From: [Hoffman, Jemae](#)
To: [Jason Kintner](#)
Cc: [Lamon, Luke](#); [Henry, Brian](#); [Lamon, Luke](#); [Benson, Charles](#); [Noll, Mark](#); [Ross Freeman](#); [Kirsten Taylor](#)
Subject: Final Council Question Response
Date: Wednesday, June 12, 2019 5:22:22 PM
Attachments: [Exec Fig2-REVISED_working file with circles and dimensions \(002\).pdf](#)
[19.06.12 Additional Questions from MI_FINAL.docx](#)

Mercer Island City Council Questions/Data Requests provided by Kirsten Taylor, Mercer Island Project Manager on May 14, 2019

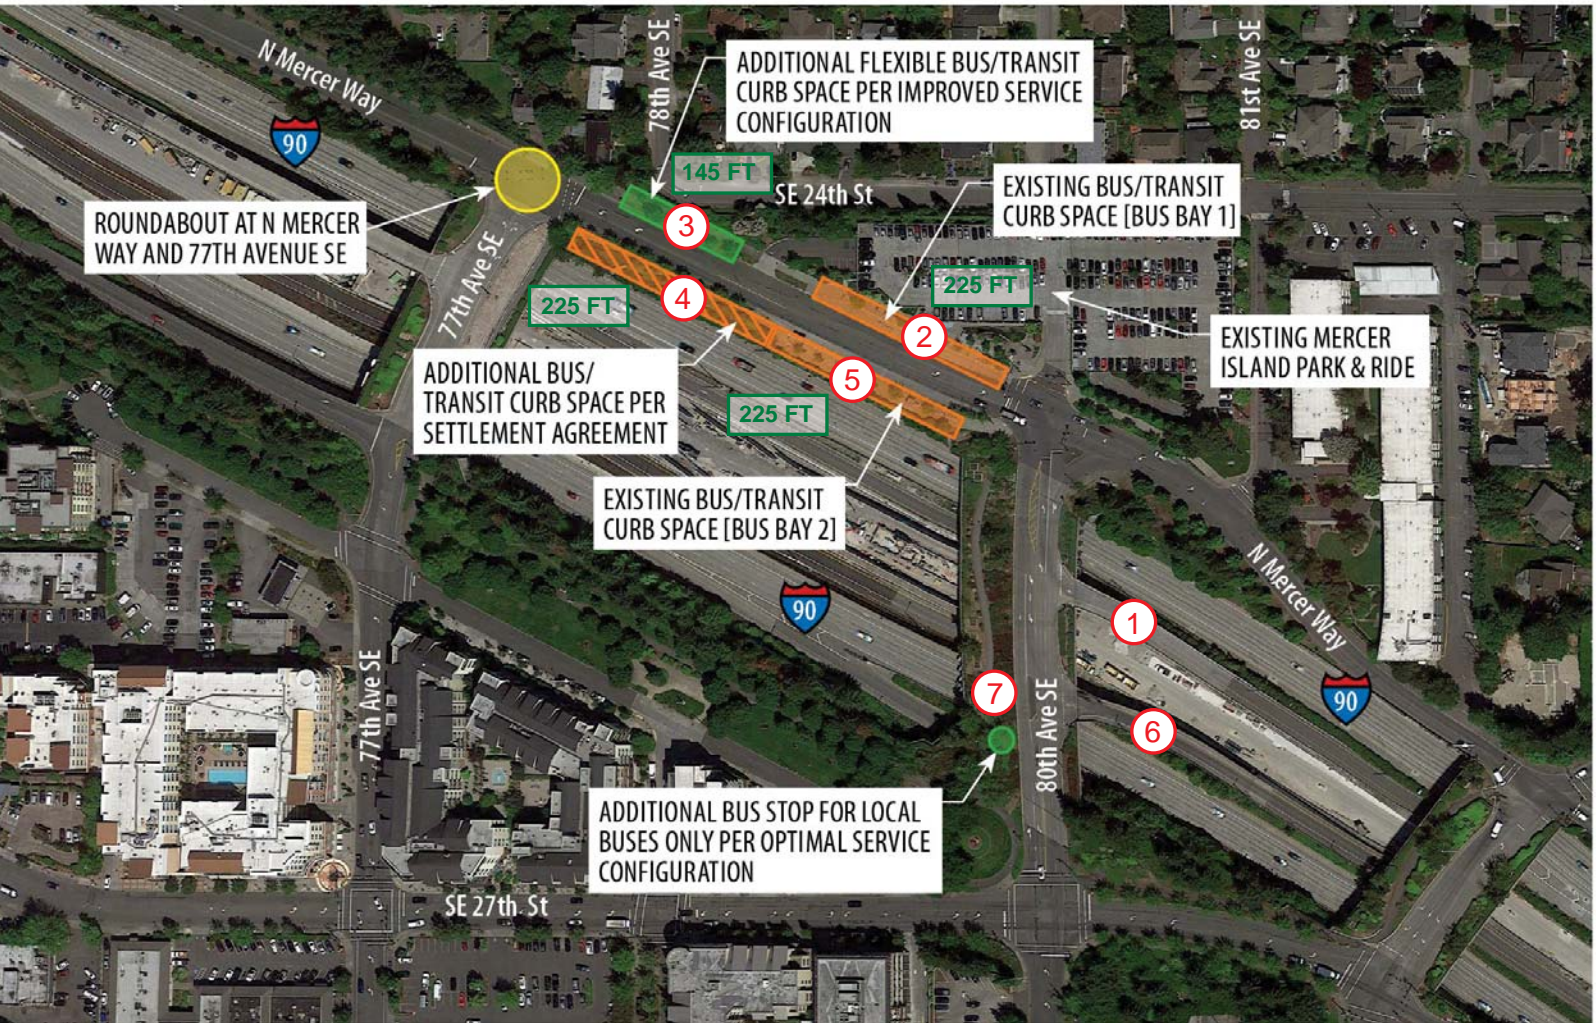
- 1) Subsequent to completing the DEA Study, we were asked to add the length of the flexible layover space on the attached diagram. I hope this visual helps describe the length of the flexible layover space on the north side of NMW. That it is smaller than 225 feet is a positive story and reflection of us incorporating Mercer Island and WSDOT input into the design.

Thanks! These are helpful and make sense. Regarding the layover, the Evans report says the space is approximately 225 feet. I assume that since the team has been refining the design, moving towards 60%) that the layover space has shrunk a bit? I'm thinking in terms of messaging here – this is a community and Council concern, it would be good to illustrate the change.

f. What is the layover space requirement for the proposed layover on the north side of N. Mercer Way?

- In response to Mercer Island City Council concerns and the amount of space available, the length of the flexible curb space/layover on the north side of NMW was designed to be only 145 feet, which is the smallest it can be and still meet KCM's operational needs for independent bus movement.

In response to Mercer Island City Council concerns and the amount of space available, the length of the flexible curb space/layover on the north side of N. Mercer Way was designed to be only 145 feet, which is the smallest it can be and still meet Metro's operational needs for independent bus movement. Please see the attached illustration of the length of the flexible curb space. The 30% design drawings show the how the layover space is tapered, which will be finalized as we move forward to 60% design.
